HARMONIZATION WITH THE UN MODEL REGULATIONS  
ON THE TRANSPORT OF DANGEROUS GOODS

Carriage of dangerous goods packed in limited quantities

**Proposals to keep the current logic and to amend Chapter 3.4 to achieve harmonisation to the other transport modes**

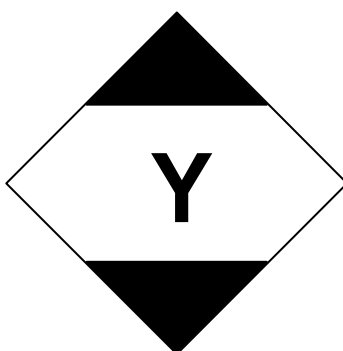
- ~~3.4.6 Any segregation provisions for dangerous goods packed in limited quantities need not apply within a vehicle or container.~~
- 3.4.7 Except for air transport, packages containing dangerous goods in limited quantities ~~need not be labelled nor marked [ see Inf. 48, SP 625!]~~ ~~with the proper shipping name or UN number of the contents, but~~ shall bear the marking shown below.

The marking shall be readily visible, legible and able to withstand open weather exposure without a substantial reduction in effectiveness.

The top and bottom portions and the surrounding line shall be black. The centre area shall be white or a suitable contrasting background. The minimum dimensions shall be 100 mm × 100 mm and the minimum width of line forming the diamond shall be 2 mm. If the size of the package so requires, the dimension may be reduced, to be not less than 50 mm × 50 mm provided the marking remains clearly visible.
